**YPSILANTI
TOWNSHIP**
— PLANNING & ZONING DEPARTMENT —

Preliminary Site Plan and Special Use Review For Ypsilanti Township, Michigan

Applicant:	UPH Ypsilanti Property LLC (Represented by Charles Paisley)
Project Name:	Culver's Restaurant and Drive-Through
Plan Date:	July 18, 2024
Latest Revision:	December 20, 2024
Location:	1410 Huron St. (On west side of South Huron Street, just north of Aldi site at Brinker Way)
Zoning:	FB, Form Based District – Town Center
Action Requested:	Preliminary Site Plan and Special Use Approval

SITE LAYOUT PLAN
CULVERS - YPSILANTI
PART OF SECTION 16, T3S, R7E
YPSILANTI TOWNSHIP, WASHTENAW COUNTY, MICHIGAN

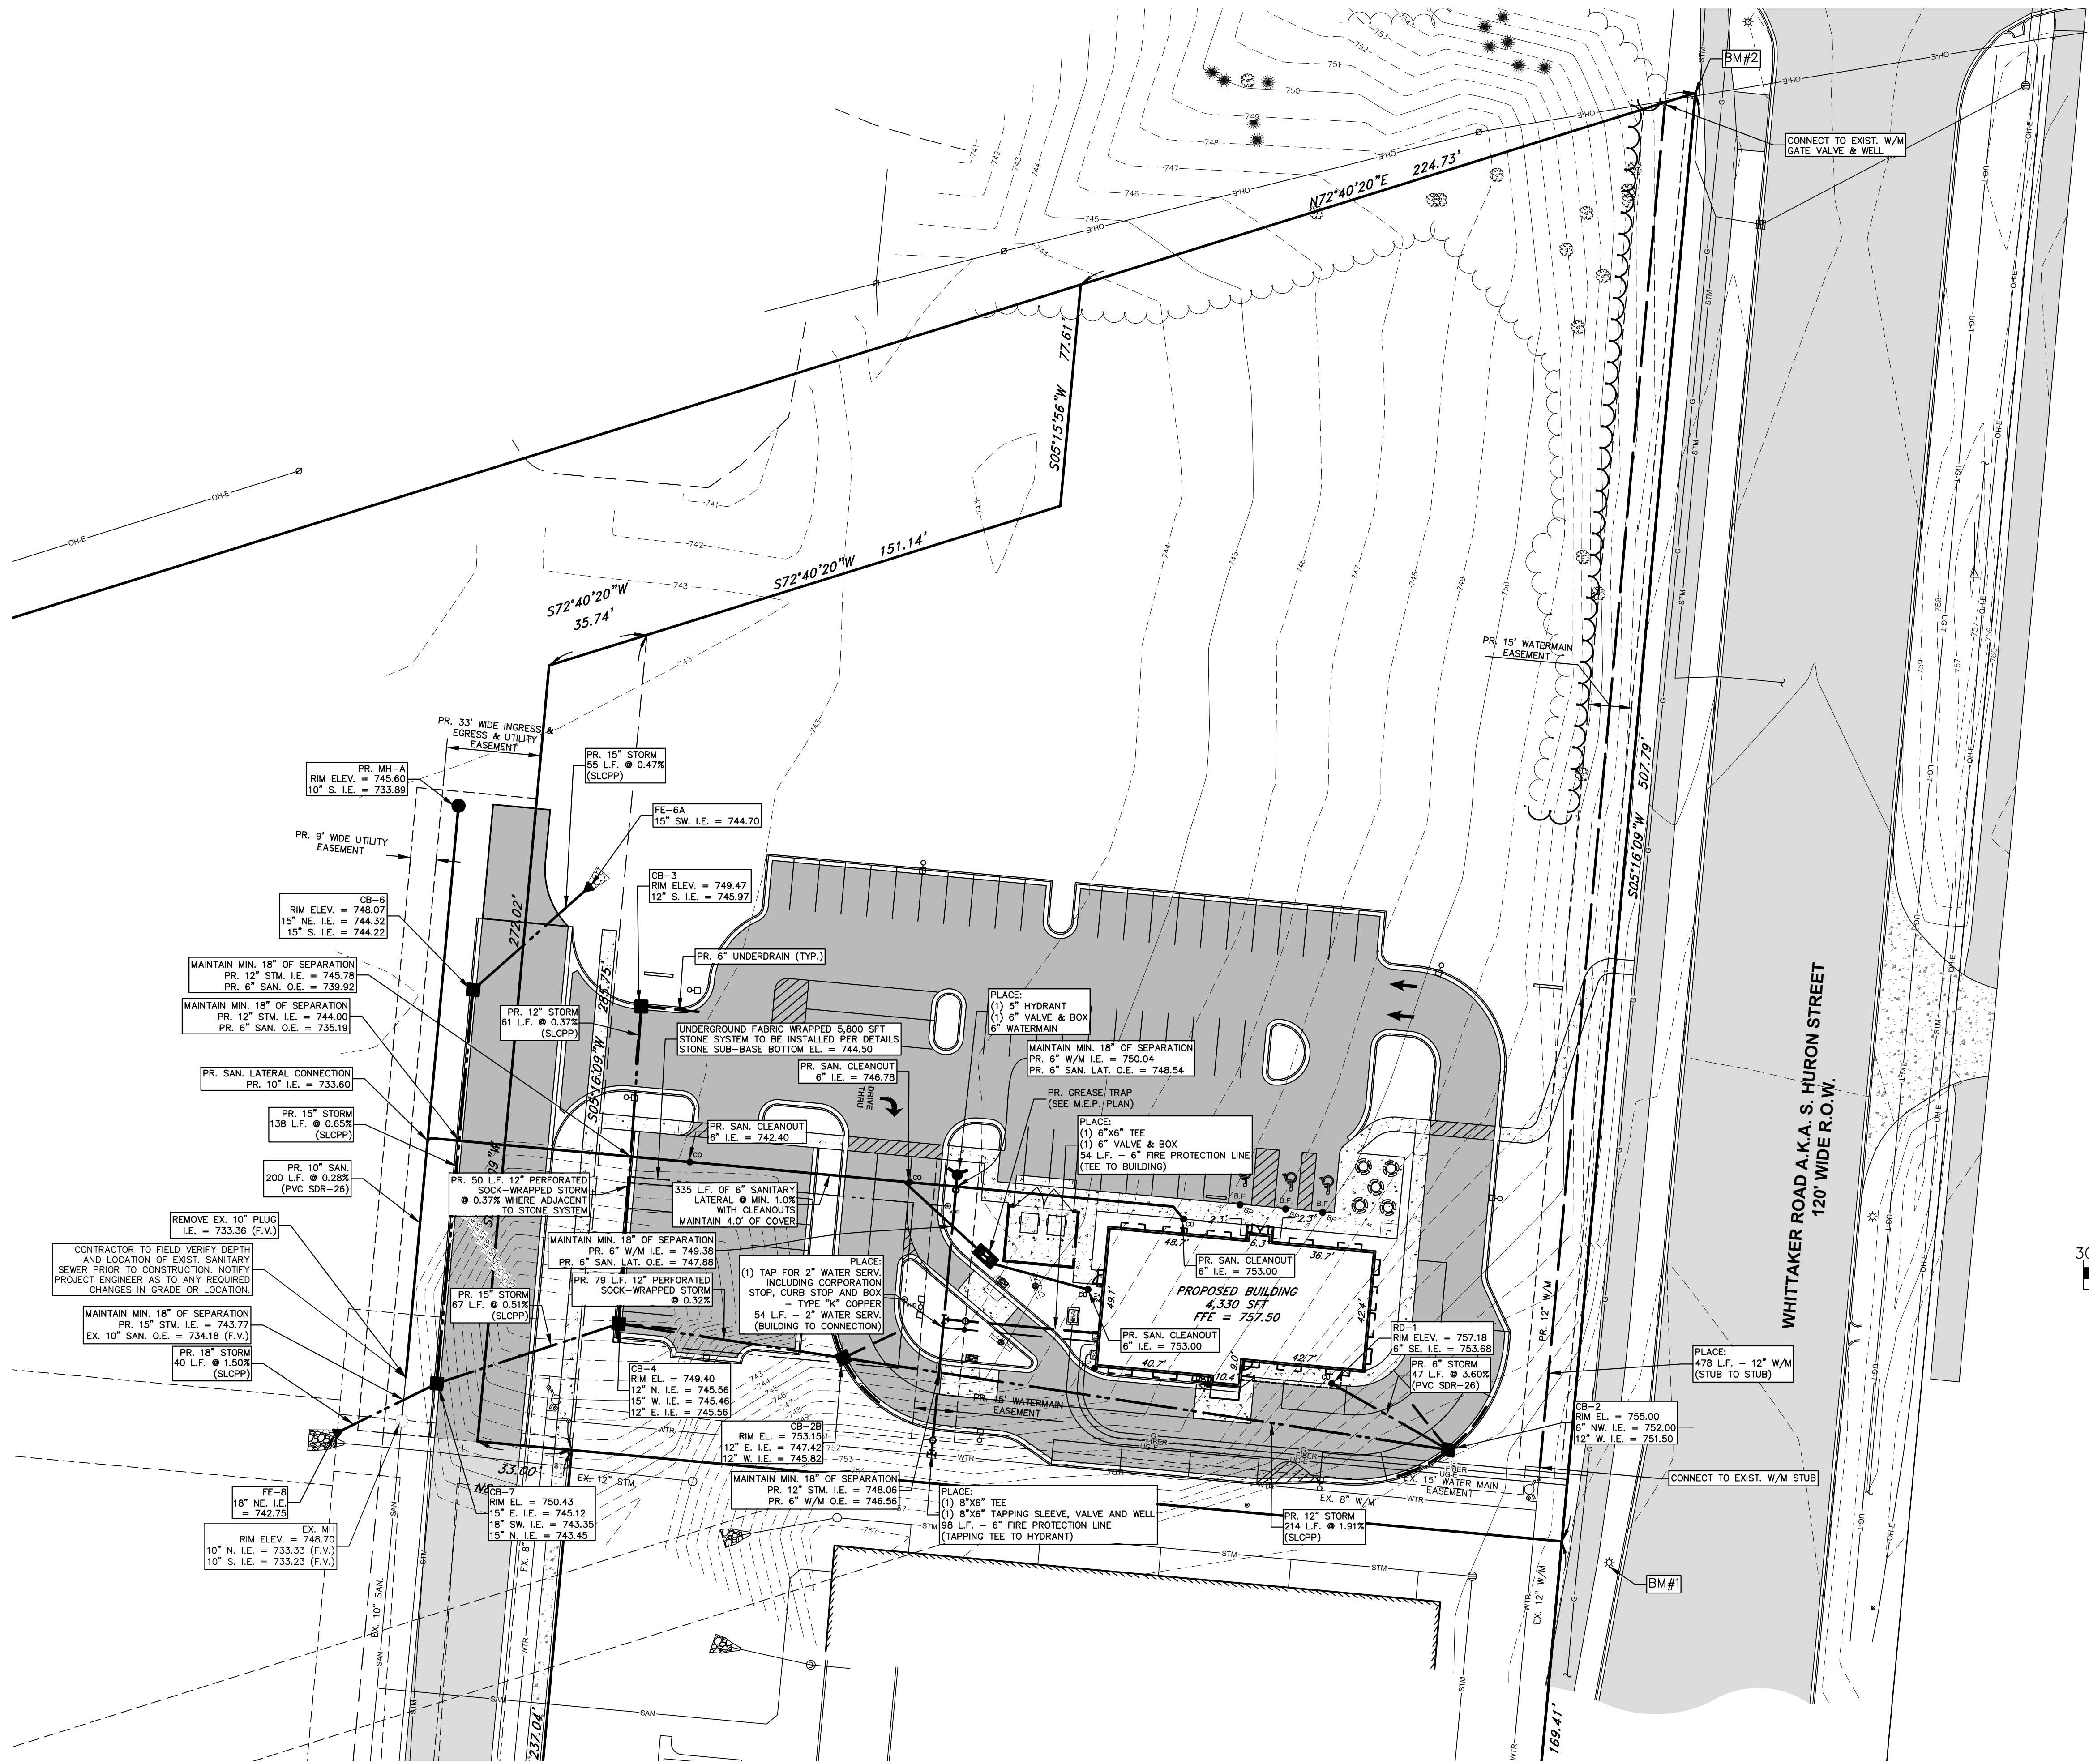
Loading/Unloading Space. The Form-Based ordinance and site plan requirements state that a loading/unloading space and specifications be shown on the plans. The revised plans show a 10' x 55' loading space on the north side of the building. The Form-Based ordinance goes on to state that the loading space shall be designated by markings or signage to limit conflicts between delivery vehicles and patrons. Sheet C-102 explains that this space will not be stripped in the field, and loading will only occur during non-business hours. Sec. 1207(2)(F) gives the Planning Commission the ability to grant a waiver in the loading space requirements. The Planning Commission should determine if striping/signage is needed to identify the loading space on site.

- a. As mentioned in our previous review, three (3) parking spaces are located directly in front of the dumpster screen. Sheet C-102 on the revised plans notes that trash haulers will be scheduled during non-business hours (or 7am-10am) and will not conflict with customer use of the adjacent parking spaces or sidewalk. As requested, the turning movements of a trash hauler are shown on the plans.

Fire truck and delivery truck turning movements are shown on Sheet C-102.

7. Applicant to provide documentation regarding loading/unloading activities, and lack of loading/unloading space shown on the plans.
Sheet C-102 describes unloading activities and shows the required space.

8. Applicant to describe how trash will be handled and at what time of day to confirm it does not conflict with adjacent parking spaces.
Sheet C-102 describes refuse handling activities and timing.

9. Show trash hauler turning movements on the plans to confirm dumpster can be accessed.
Provided as requested on Sheet C-102.
10. Relocate service/escape lanes out of the front yard or seek variance.
Site layout modified and supported by Township staff and planner per communications.

14. Show how delivery trucks will circulate around the site.
Provided as requested on Sheet C-102.
15. Reconsider design of sidewalk connection to eliminate the need to cross vehicular travel lanes.
Site layout modified and supported by Township staff and planner per communications.

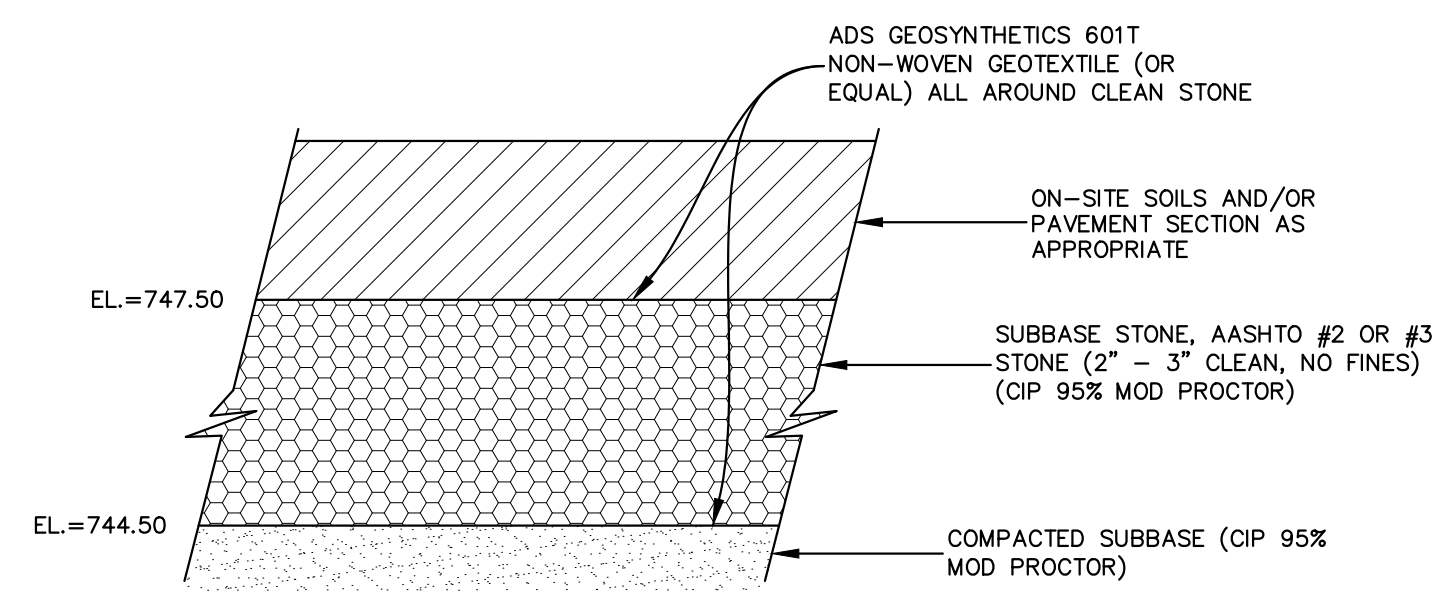
6. The applicant shall verify the invert elevations of CB-6 as there appears to be discrepancies between the plan view (Sheet C-103) and the profile view (Sheet C-203).

9. The applicant shall verify the rim/invert elevations and the name of the proposed sanitary sewer manhole on to the northwest as there appears to be discrepancies between the plan view (Sheet C-103) and the profile view (Sheet C-202).

6. The underground fabric wrapped stone section detail shown on plan sheet C-103 indicates the bottom of the stone bed has been set at Elevation 744.50. The perforated pipe running between CB-3 and CB-4 appears to be the only means to direct runoff into the stone bed. The pipe invert is noted as Elevation 744.50. Since the site cannot provide infiltration, it is unclear how any runoff will enter utilize the stone storage bed since the volume in the stone above the pipe will not be utilized unless the perforated pipe is full of water and there is an outlet structure located within CB-4. Reference to a 1/5=inch diameter outlet orifice is made on plan sheet C-105 but no outlet detail is provided. a. Outlet calculations should follow the example shown in the rules for a single-stage outlet.
As discussed with staff, the outlet was previously provided on Sheet C-501 and the stone system will function to provide water quality detention as required.
